JOB TITLE: Priority Lane, Marcham  
 CLIENT: Manor Dak Hones  
 DRAWING TITLE: Proposed Footway  
 SCALE: 1/500@A3  
 DRAWN BY: BP  
 DATE: 03/06/13  
 DRAWING NO: 14123-03  
 REVISION: B

**APPLICATION WEB COMMENTS FORM****Information available for public inspection and available on our website****Location :** Land to the North of Priory Lane Priory Lane Marcham Oxfordshire**Proposal :** Proposed development of 18no. dwellings with garages, access road, associated works, public open space and a detention basin. (Re-submission of withdrawn application P12/V2447/FUL.**Application Reference :** P13/V0859/FUL - 1

<b>Your name :</b>	Marcham Parish Council
<b>Your address :</b>	ORCHARD HOUSE 90 HOWARD CORNISH ROAD MARCHAM ABINGDON OX13 6PU
<b>Date :</b>	22 May 2013
<b>Response :</b>	Refused

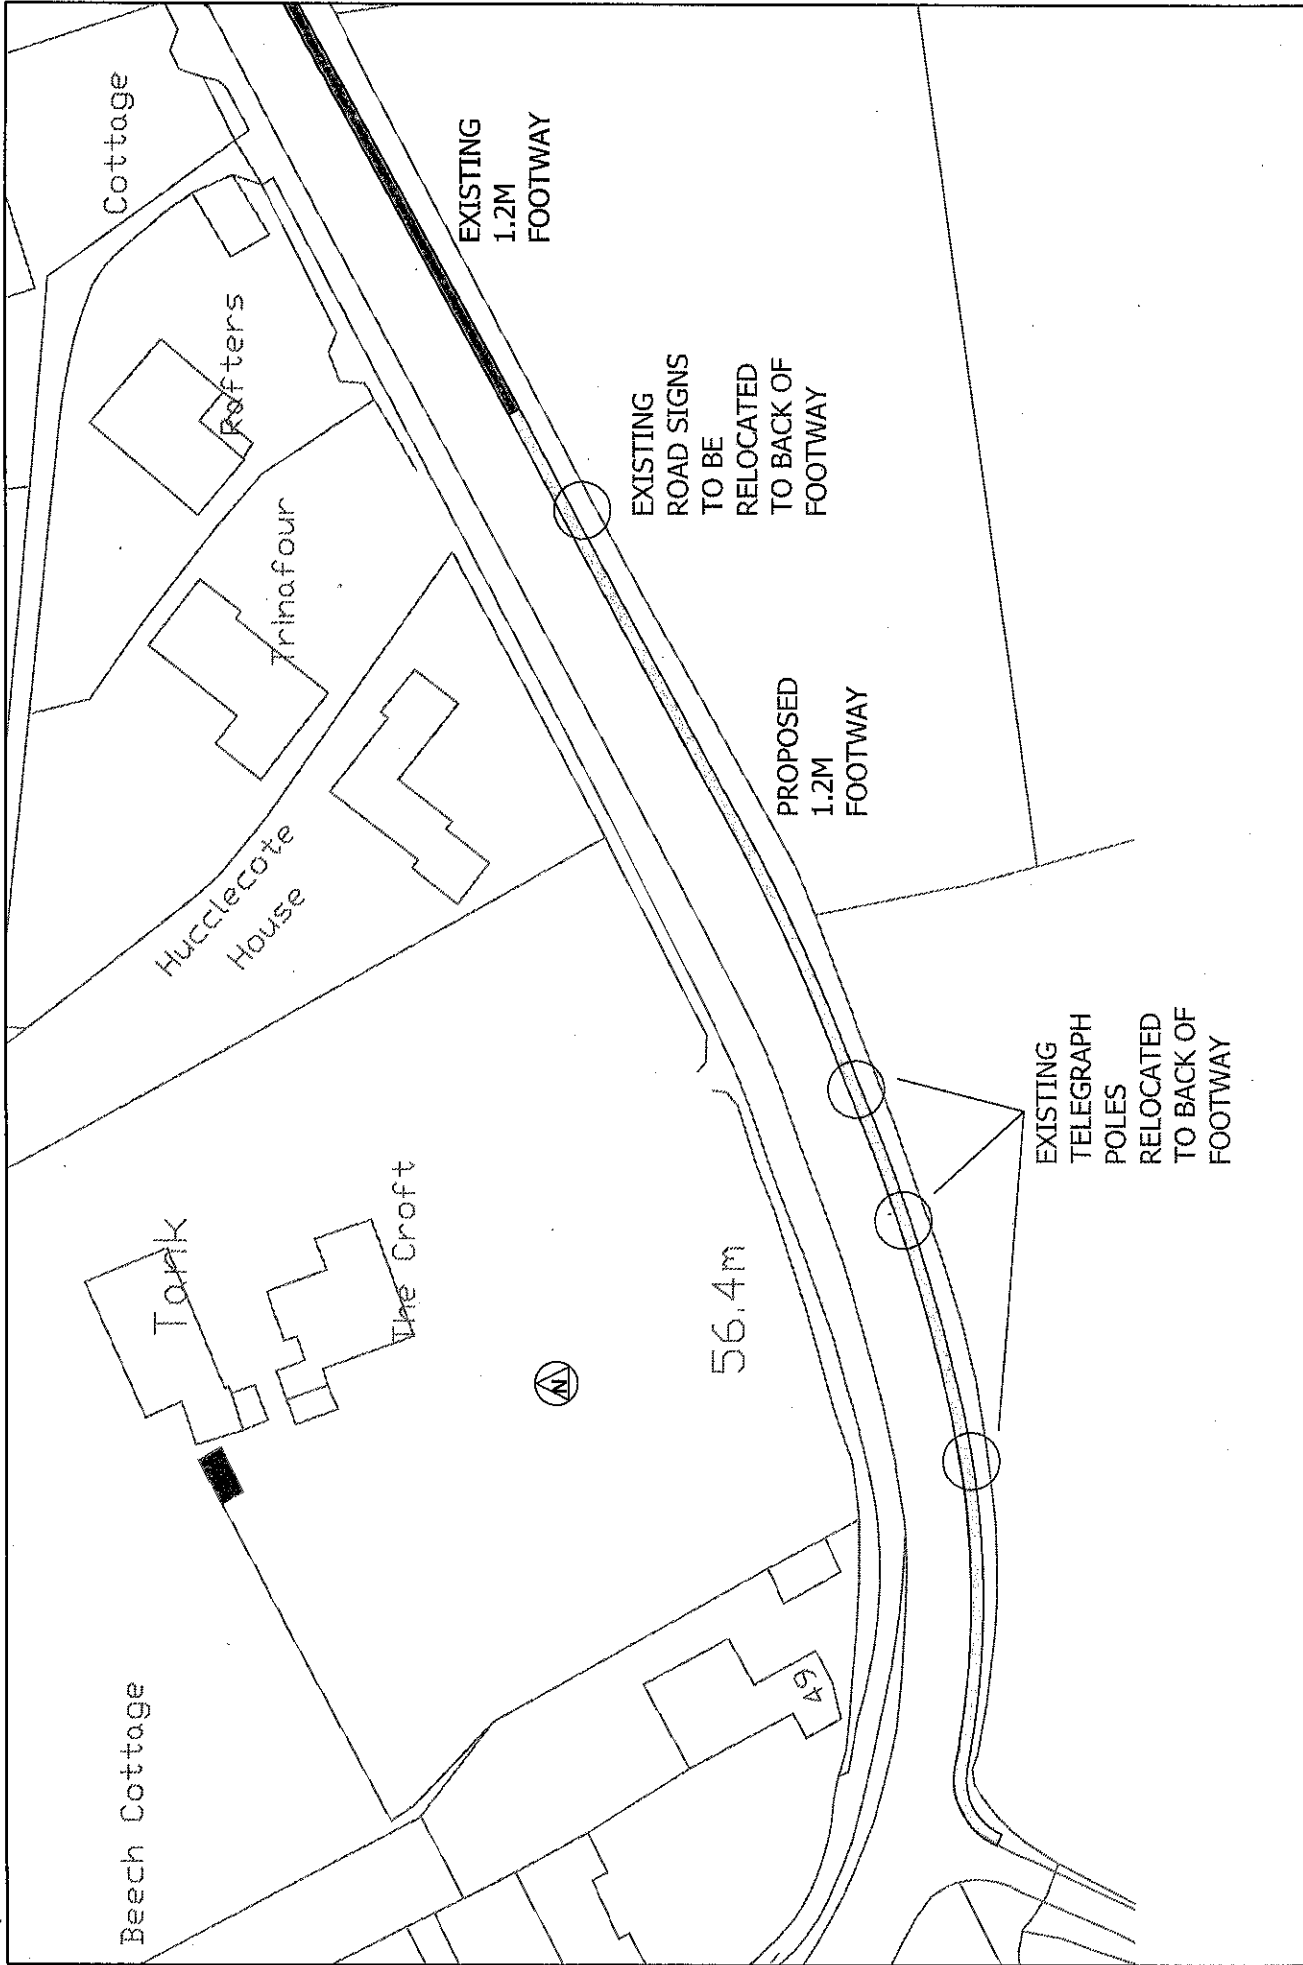
A second major concern with the revised scheme is the lack of footway from the entrance to the site, to the traffic light crossing over the A415, eastwards of the entrance. The original scheme showed a footway link. The village school, churches, shop, recreation facilities and bus stops are all on the northern side of the A415. Primary school children will not be able to walk to school within the village, in safety, unless the footway alongside the A415 to the traffic lights, as shown on the first application is reinstated.
